STAFF REPORT
COMMUNITY DEVELOPMENT DEPARTMENT

HEARING DATE: Janaury 5, 2023
 TO: Planning & Zoning Commission
 FROM: Stacy Hersh, Associate Planner
 208-884-5533
 SUBJECT: H-2022-0077 – Dutch Bros Ustick & Eagle MDA, CUP
 LOCATION: 3117 E. Ustick Rd., in the NE ¼ of Section 5, Township 3N., Range 1E. (Parcel #R9161790045)

The Applicant has submitted an application for a modification to the existing Development Agreement (H-2019-0082, Inst. #2019-121599) to update the existing concept plan; and conditional use permit to construct a new 1,154 square foot restaurant with associated drive-through on approximately 1.2 acres of land in the C-G zoning district.

C. Proposed Dutch Bros. Coffee Site Plan (date: 10/11/2022)

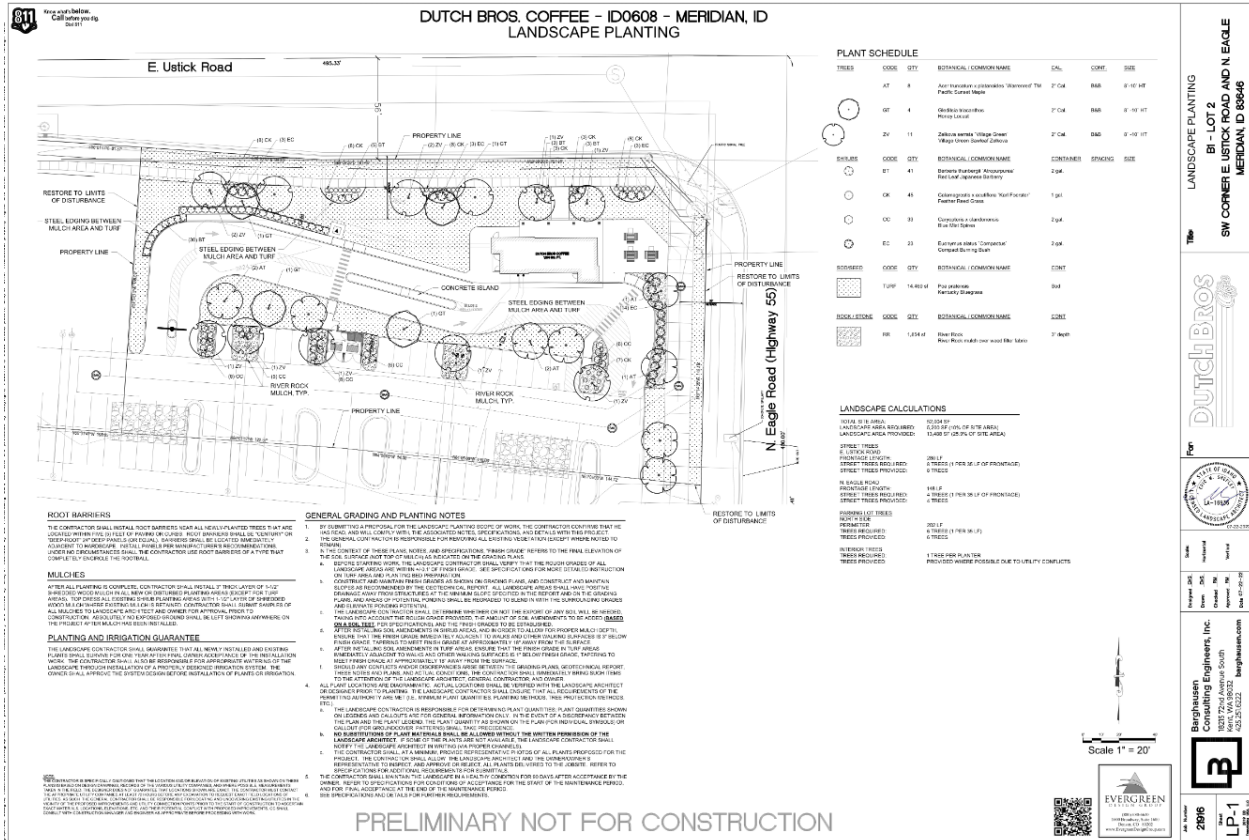
Drive-Through Establishment: The proposed drive-through establishment is subject to the specific use standards listed in UDC [11-4-3-11](#), Drive-Through Establishment. All establishments providing drive-through service are required to identify the stacking lane, menu and speaker location (if applicable), and window location on the site plan. *A menu board location should be depicted on the plans.* The site plan

The concept plan shows the stacking lane is a separate lane from the drive aisles and parking which provides access to the rest of the development. The proposed site layout places a drive-through that starts at the southwest side of the building and exits at the southeast side of the building facing N. Eagle Road. Approximately 524 feet of stacking space is available behind the drive-through window to provide queuing for up to 26 vehicles. Dutch Bros. coffee has proposed implementing a runner system at the facility that is designed to increase speed and efficiency in servicing the drive-through customers; as well, employees will travel from vehicle to vehicle to greet and take customer orders. The "Runners" will utilize a handheld device to transmit customer orders to the multiple drink stations inside the building. Additionally, "Runners" will charge customers while in line, so by the time they arrive at the service window, they may pick up their order and be on their way. This system decreases wait times while allowing the "Runners" to have a more personal face-to-face interaction with the customers. The drive-through will not include any speaker boxes. All customer orders are taken in person either at the window or with a runner that carries a handheld device to transmit orders to the kitchen. This order process will minimize noise impacts and also decrease the amount of vehicle idling at menu boards that are common at traditional drive-through facilities. If there was additional or excessive overflow from the drive-through lane which does sometimes occur from drive-through establishments at peak times, it would stack into the parking lot from the west, not into N. Cajun Lane or E. Ustick Road.

The stacking lane exceeds 100' in length and an escape lane is required. An escape lane is proposed prior to approaching the ordering window on the southeast side of the building.

2. The site plan and landscape plan submitted with the Certificate of Zoning Compliance application shall be revised as follows:
 - a. The stacking lane, and menu location(s), and window location shall be depicted in accord with UDC [11-4-3-11B](#).

- c. Additional signage and parking lot striping is required throughout the site to efficiently and adequately direct patrons to the menu boards and throughout the site with minimal conflict.

- f. Depict signage ahead of each pedestrian crossing in the drive-through lane notifying drivers to watch out for pedestrians.
3. Compliance with the standards listed in UDC [11-4-3-11](#)– Drive-Through Establishment and standards listed in UDC [11-4-3-49](#)– Restaurant is required.

D. Proposed Dutch Bros. Coffee Landscape Plan (dated: 7/21/2022)

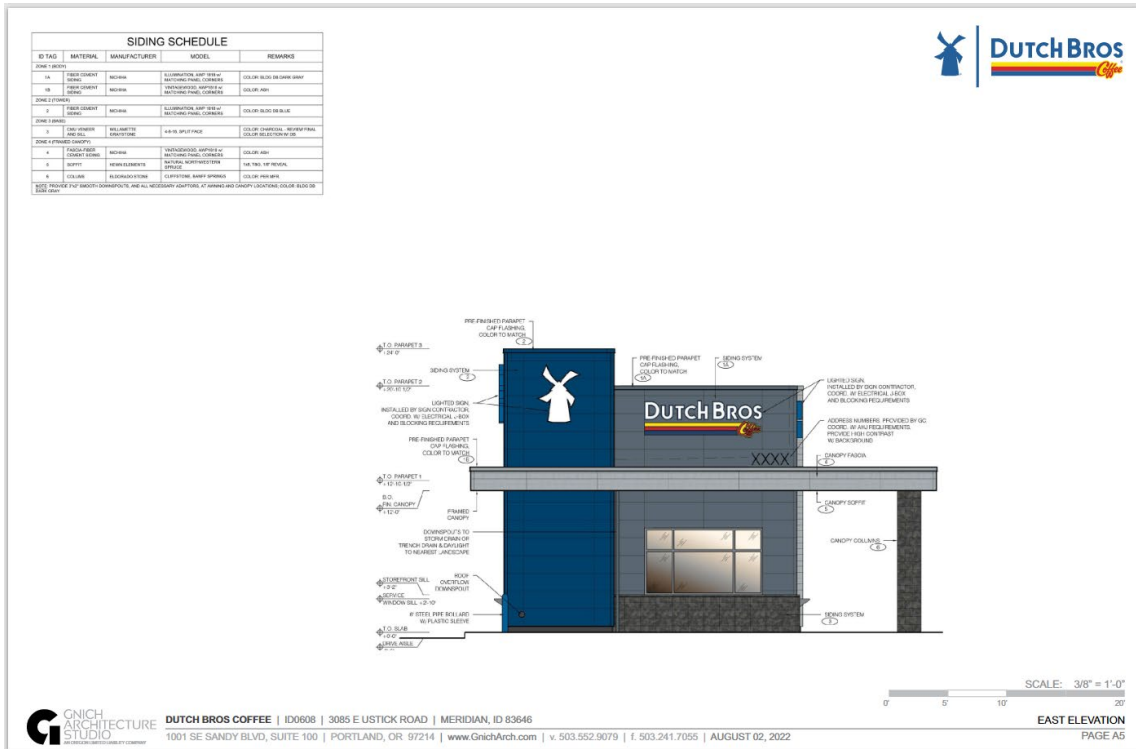
Parking lot: Landscaping is required in the parking lot per the standards in UDC 11-3B-8C.1. **The perimeter landscape buffer shall be planted with one Class II or Class III tree per thirty-five (35) linear feet and shrubs, lawn, or other vegetative ground cover. The perimeter landscape buffer next to the drive-through lane on the west side of the site is missing a mix of trees, shrubs, and River Rock mulch on the landscape plan submitted with the CUP.** All other landscaping appears to comply with UDC standards.

With the CZC submittal, the landscape plan should be revised to show the required mix of materials (i.e., trees, shrubs, River Rock Mulch) in the landscape buffer adjacent to Ustick Road, and to the parking lot perimeter landscape buffers to the north, south, and west of the drive-through lanes.

- e. Depict landscaping in the landscape buffer along E. Ustick in accord with the standards listed in UDC [11-3B-7C.3](#); landscape buffers along streets shall be designed and planted with a variety of trees, shrubs, lawn, or other vegetative ground cover that elicit design principles including rhythm, repetition, balance, and focal elements. With the CZC submittal, the landscape plan shall be revised to show the required mix of materials (i.e., trees, shrubs, River Rock Mulch) in the landscape buffer adjacent to Ustick Road.

- f. Depict landscaping in the perimeter buffer along the drive aisles and drive-through lanes in accord with the standards listed in UDC [11-3B-8C](#); the perimeter landscape buffer shall be planted with one Class II or Class III tree per thirty-five (35) linear feet and shrubs, lawn, or other vegetative ground cover. With the CZC submittal, the landscape plan shall be revised to show the required mix of materials (i.e., trees, shrubs, River Rock Mulch) in the parking lot perimeter landscape buffers to the north, south, and west of the drive-through lanes.
